Item Name: Fwd Crosstube - High 206L / L1 / L3 / L4

DART AEROSPACE LTD		Work Order:	158288
Description: Crosstube High Fwd (206L)		Part Number:	D206-667-103
Inspection Dwg: D206-667-143 Rev: C		Page 1 of 1

DRAWING NO. D206-667-143	TITLE CROSSTUBE ASS'Y (206L HIGH FWD)	REV. C	DART AEROSPACE LTD ENGINEERING ORDER		D.E.O. NO. D206-667-143-C-1	SHEET NO. SHEET 1 OF 1	SCALE NTS
DRAWN <i>q</i>	CHECKED <i>ASS</i>	MFG. APPR. <i>[Signature]</i>	APPROVED <i>MD</i>	DE APPR. <i>[Signature]</i>			
DATE 11.07.15	DATE 11.07.20	DATE 11.07.21	DATE 11/07/21	DATE 11.07.21

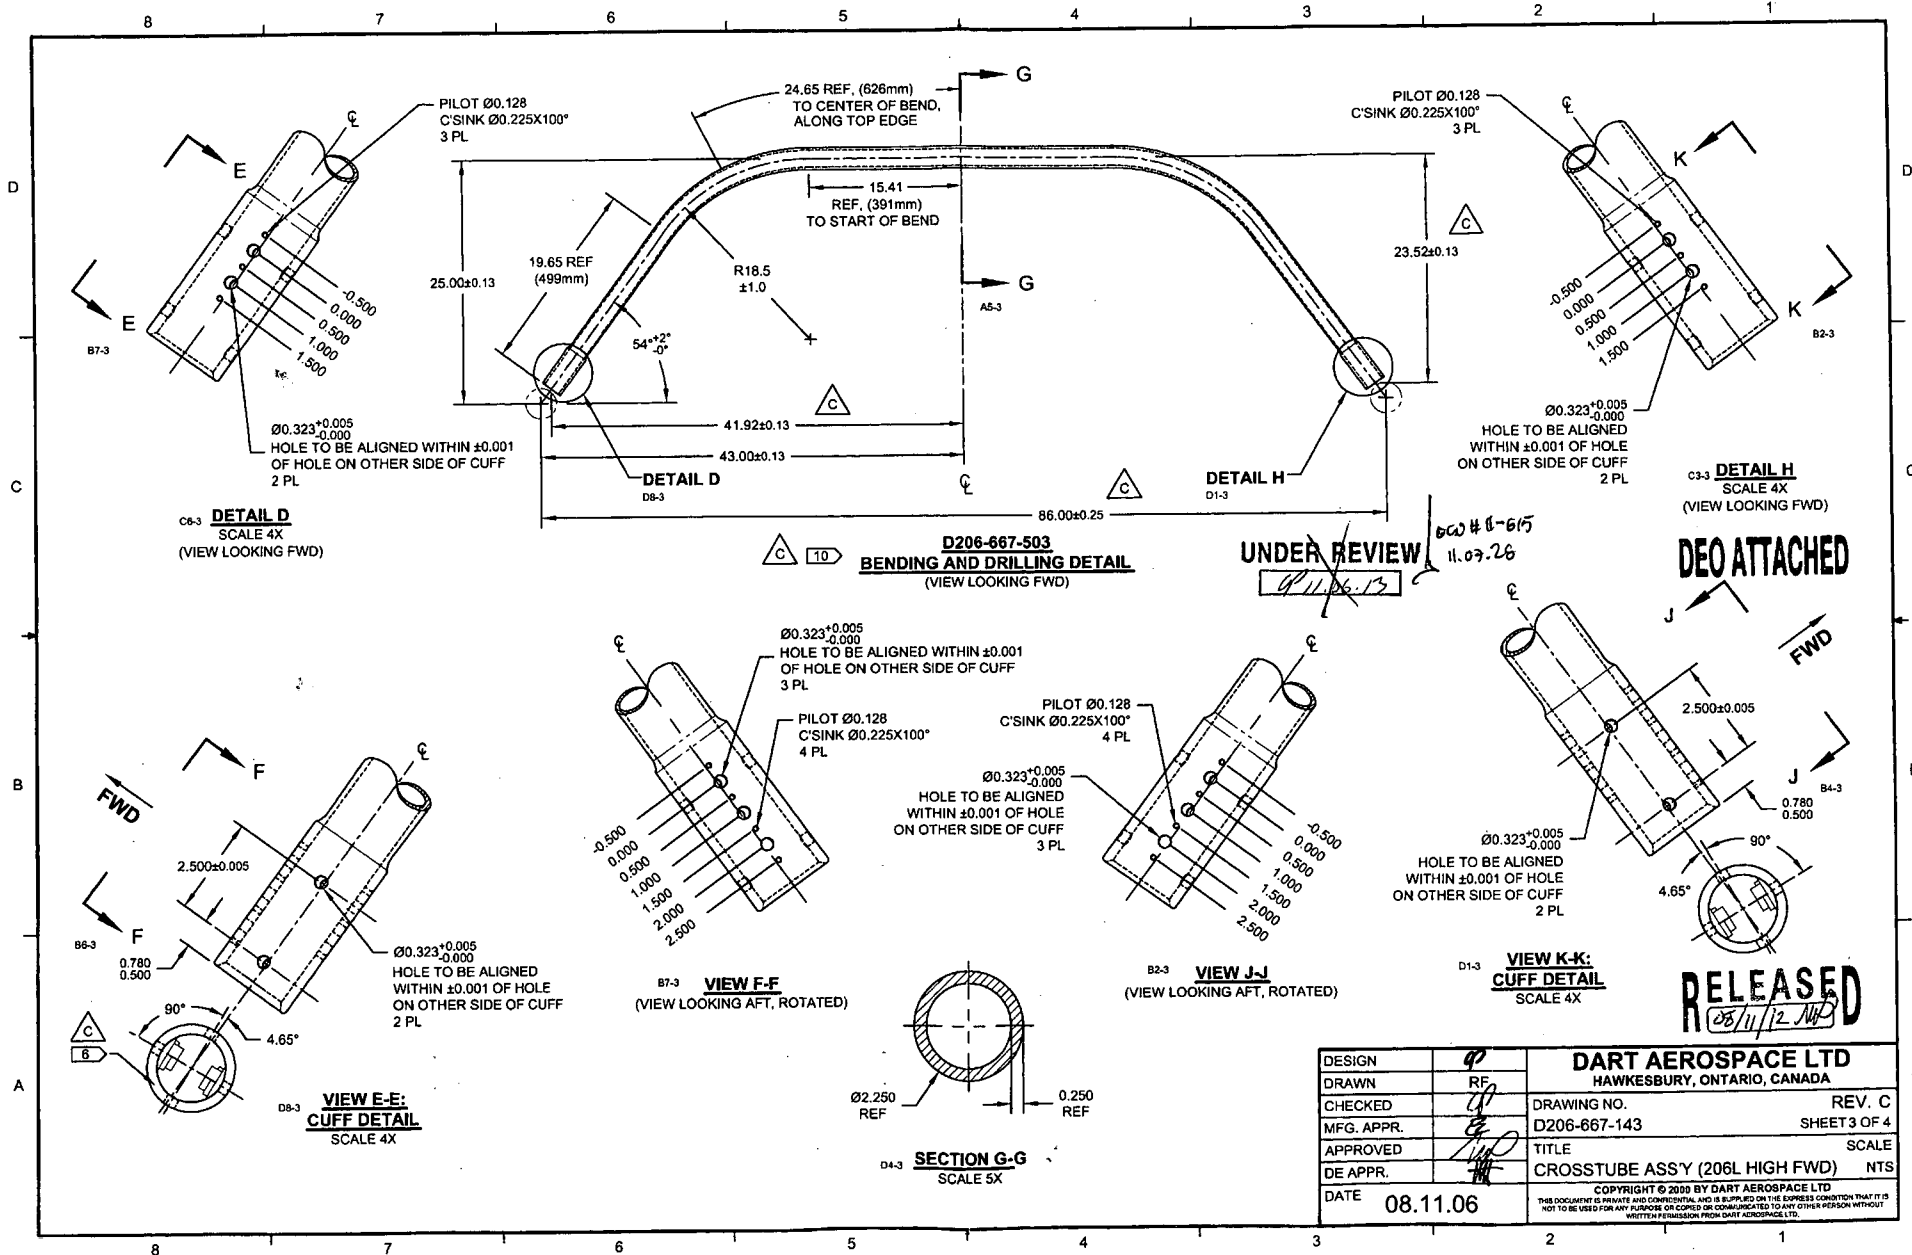
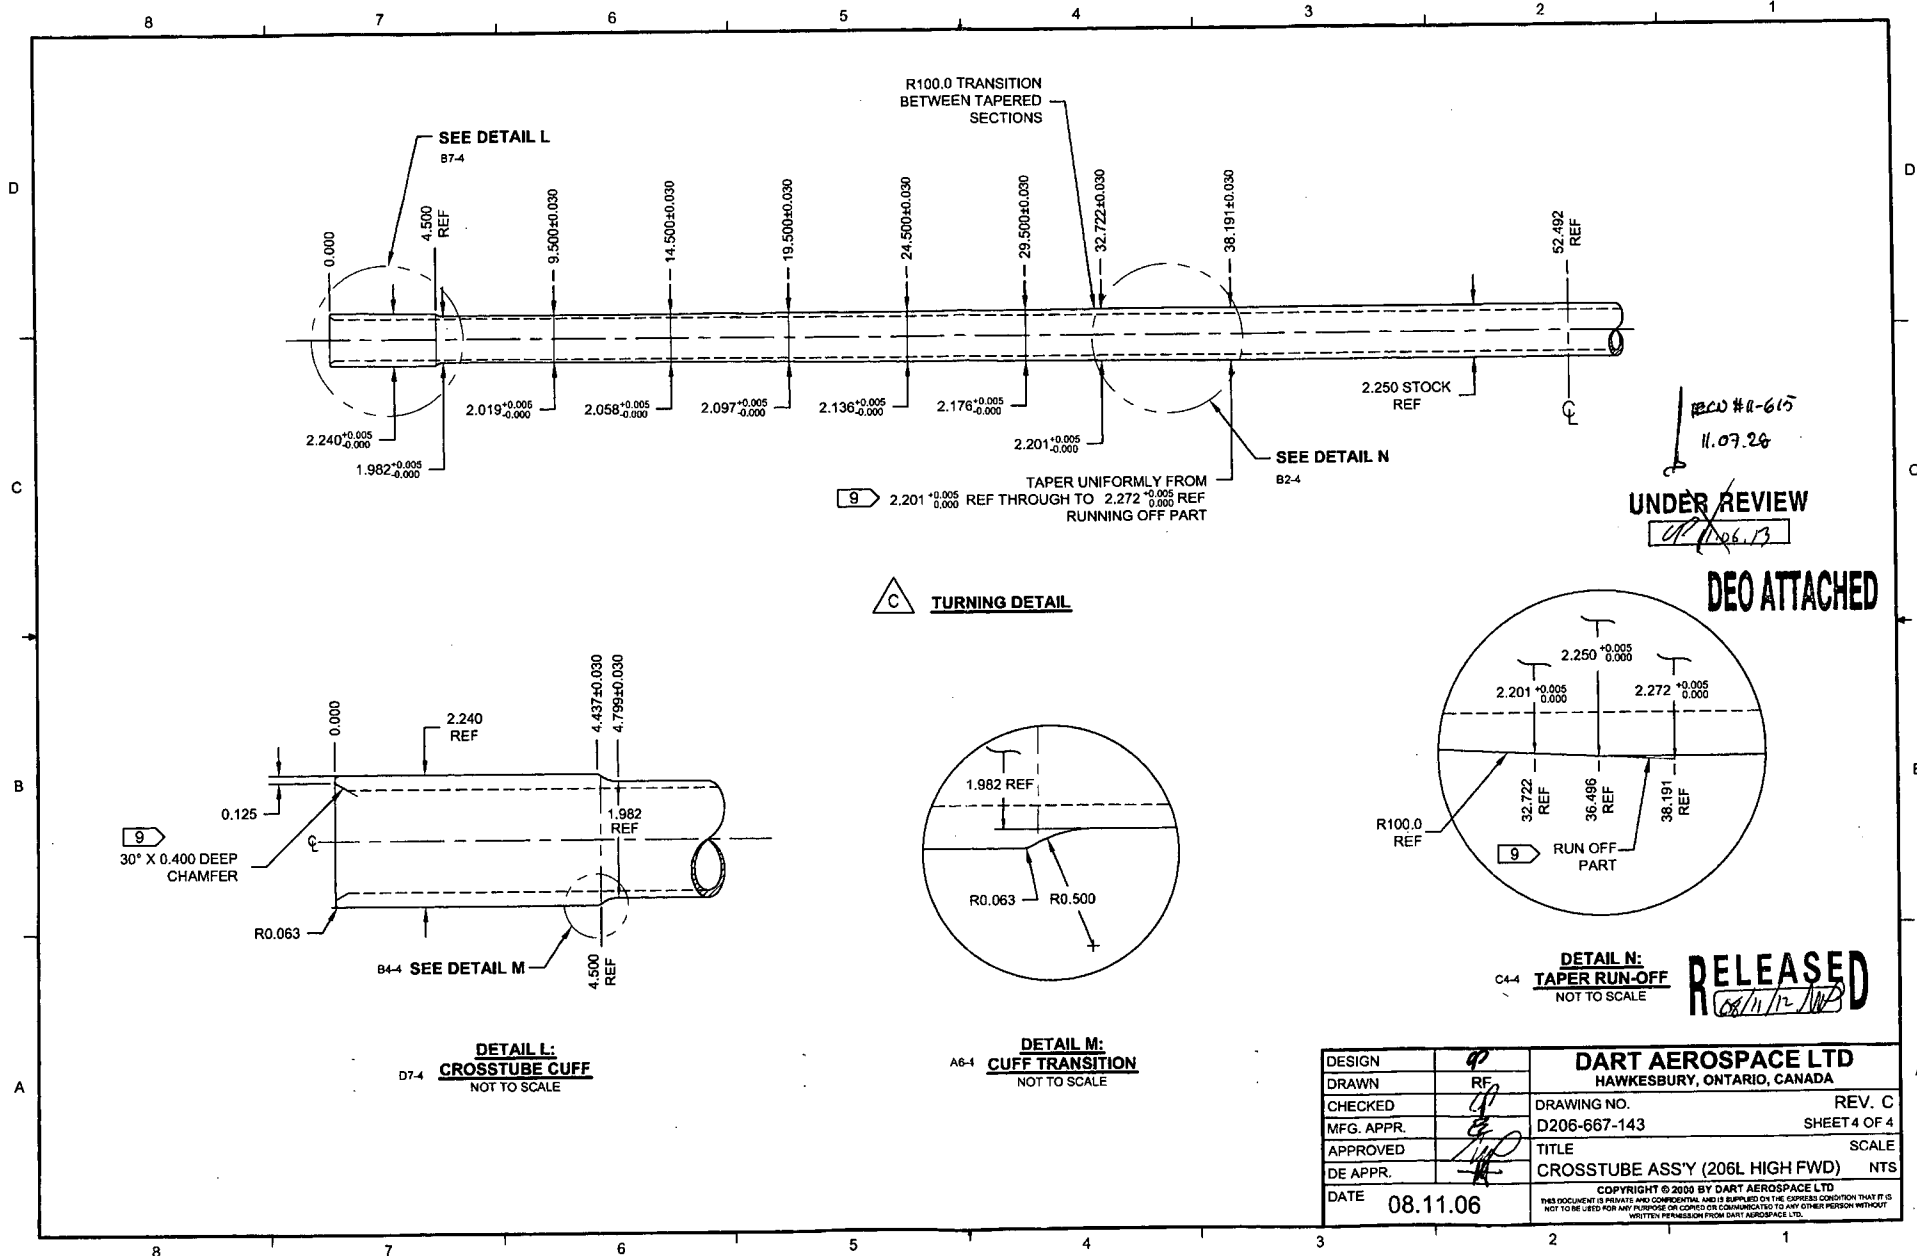
PURPOSE:

REPLACE MAGNOBOND WITH PROSEAL.

NOTE 12 & 15, SHEET 1 IS AMENDED AS FOLLOWS:

- 12) TO INSTALL D2891-1 SUPPORT: ABRASE MATING SURFACE OF SUPPORT AND CROSSTUBE WITH 180-GRIT SANDPAPER AND REMOVE RESIDUE WITH MEK (OR EQUIVALENT). APPLY A 0.04" TO 0.07" THICK LAYER OF PROSEAL 890 CLASS B-2 (OR AMS-S-8802 CLASS B-2) SEALANT TO MATING SURFACE OF SUPPORT.
- 15) TORQUE CLAMPS 80 TO 100 IN-LB. ENSURE AT LEAST 1.5 THREADS SHOWING IN SAFETY AND THAT NUT HAS NOT BOTTOMED-OUT AFTER TORQUING. **PRIOR TO PACKAGING, RE-CHECK TORQUE ON CLAMPS AFTER PROSEAL 890 SEALANT HAS CURED FOR 72 HOURS.**

DETAIL P BONDING STRAP INSTALLATION 2 PL

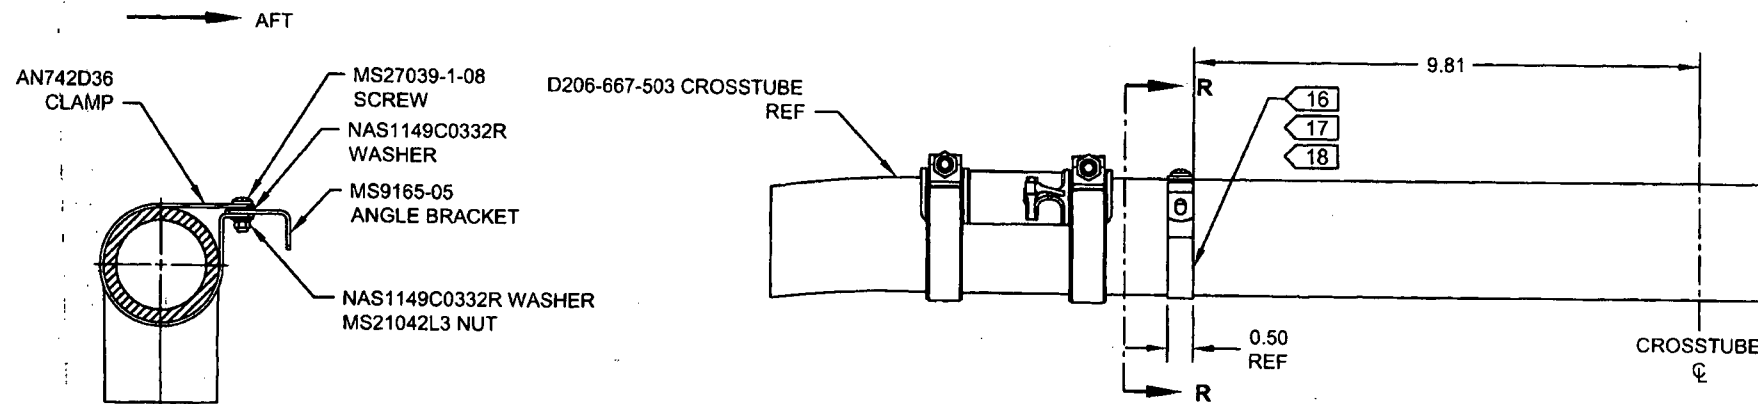
ADD ELECTRICAL GROUNDING STRAP

GENERAL NOTES:

- 16) MASK AREA UNDER CLAMP PRIOR TO PAINTING
- 17) SEAL EDGES WHERE AN742D36 CLAMP MEETS WITH THE CROSSTUBE USING SIKAFLEX-241/-291 OR MIL-S-8802 CLASS B2 OR PROSEAL 890 SEALANT
- 18) PERFORM RESISTANCE CHECK TO ENSURE MAX RESISTANCE IS 10 MILLIOHMS
